L-MT-06-034
10 CFR 50.90

Monticello Nuclear Generating Plant
Docket 50-263
License No. DPR-22

Enclosure: Applicable Portions of the U.S. Nuclear Regulatory Commission (NRC) and Monticello Nuclear Generating Plant (MNGP) Improved Technical Specification (ITS) Conversion Website

**Applicable Portions of the U.S. Nuclear Regulatory Commission (NRC) and
Monticello Nuclear Generating Plant (MNGP)
Improved Technical Specification (ITS) Conversion Website**

CTS Table 3.1.1 Function 5, Reactor Vessel Steam Dome Pressure - High

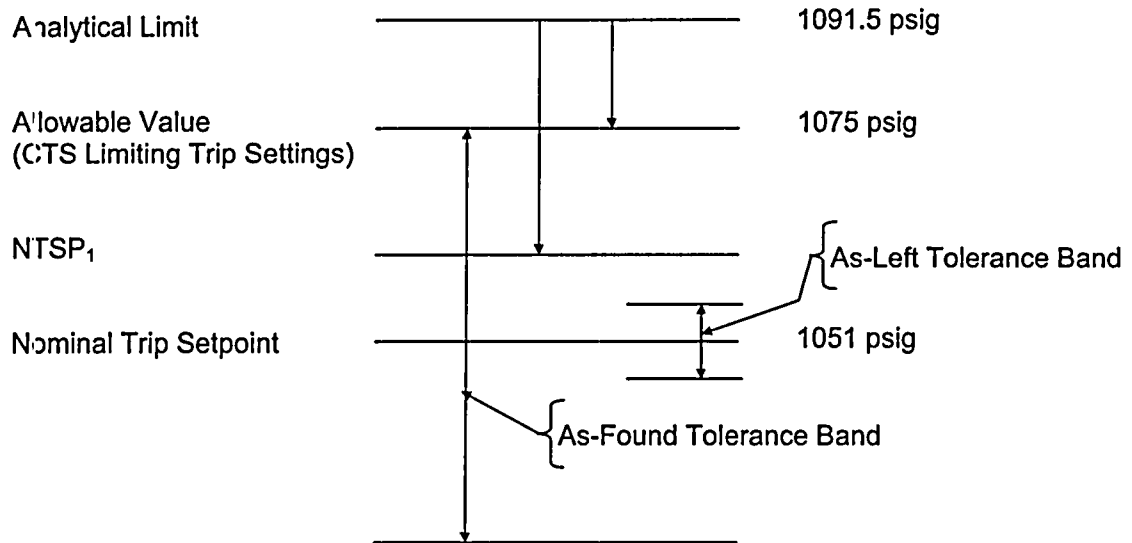
NTSP₁ is the term most similar to LSSS on the NRC diagram since it is the most limiting value of the setpoint that protects the AL.

CTS Table 3.1.1 Function 3.a, IRM Neutron Flux High - High

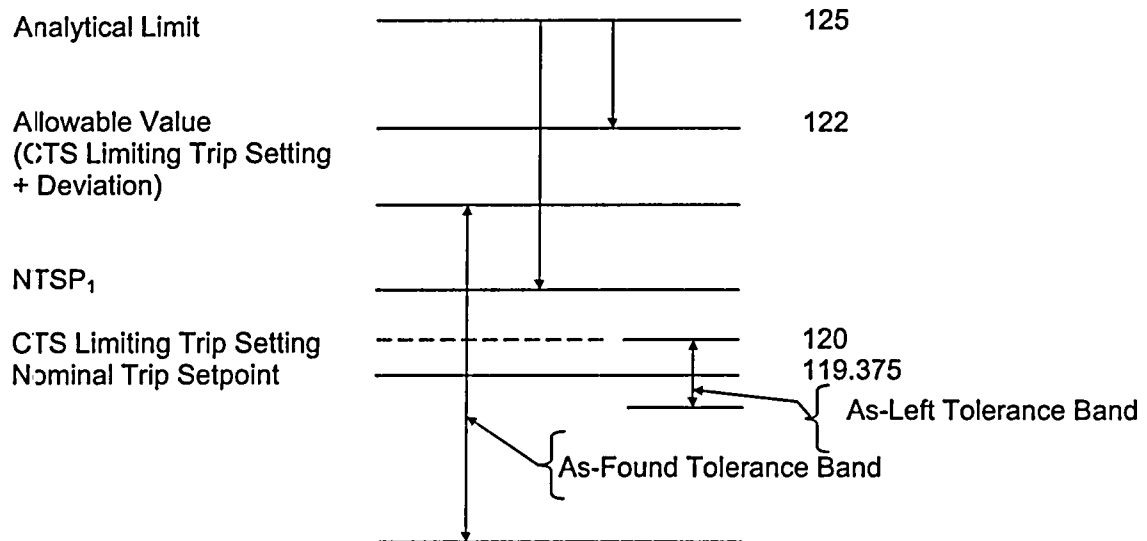
NTSP₁ is the term most similar to LSSS on the NRC diagram since it is the most limiting value of the setpoint that protects the AL.

CTS Table 3.1.1 Function 7, Reactor Vessel Water Level - Low

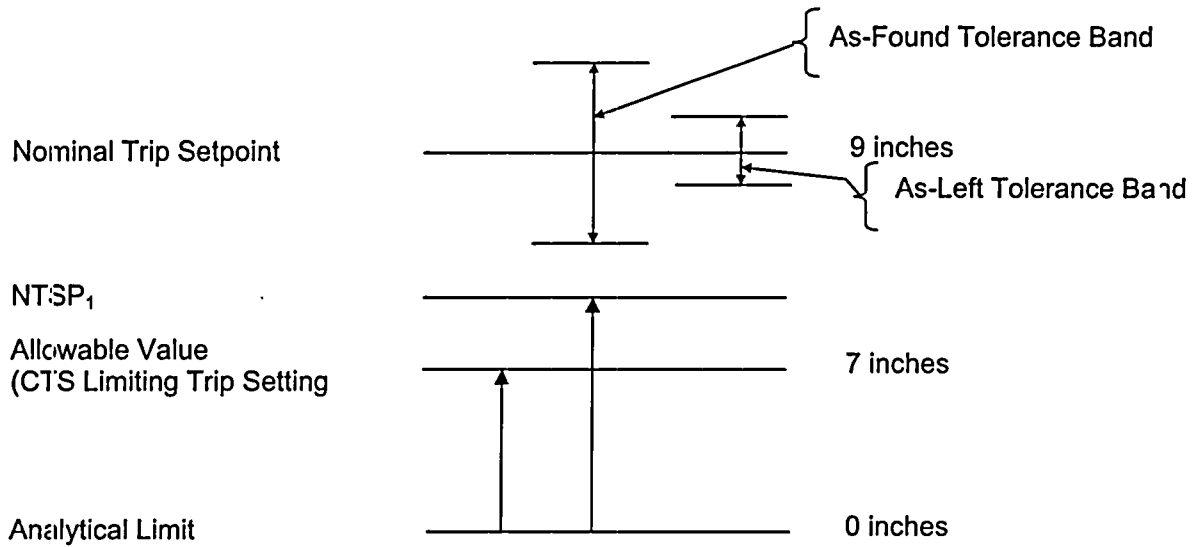
NTSP₁ is the term most similar to LSSS on the NRC diagram since it is the most limiting value of the setpoint that protects the AL.

CTS Table 3.1.1 Function 4.a and 4.c, APRM Flow Referenced Neutron Flux-High and Clamp

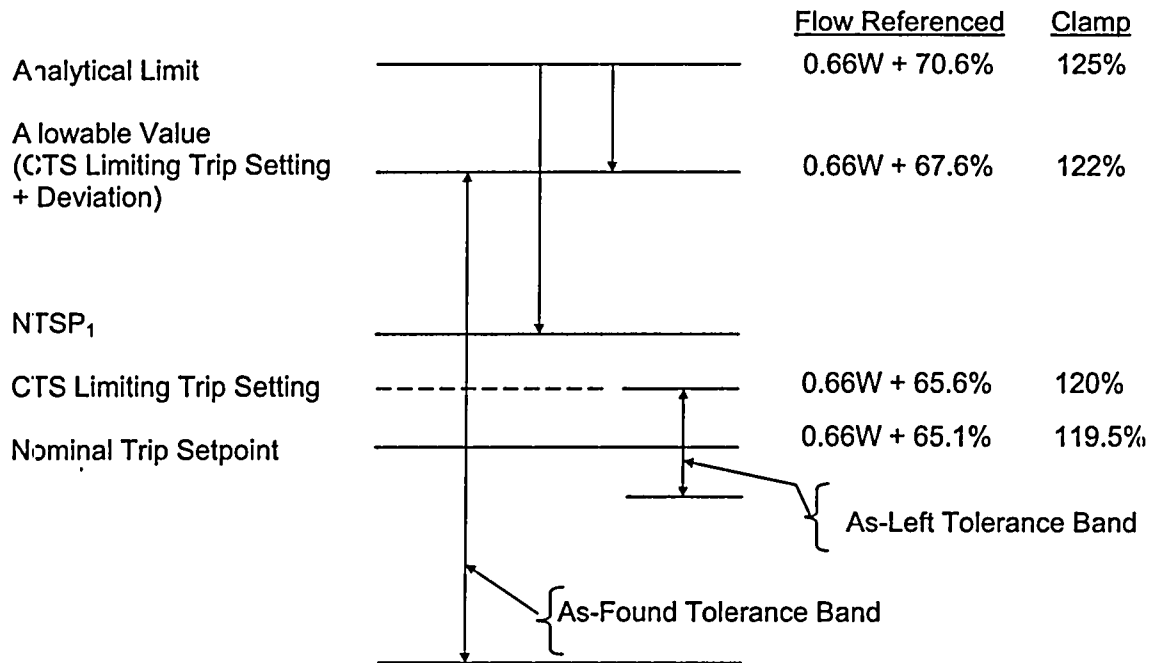
Clamp values are for flows (W) above 82.4%.
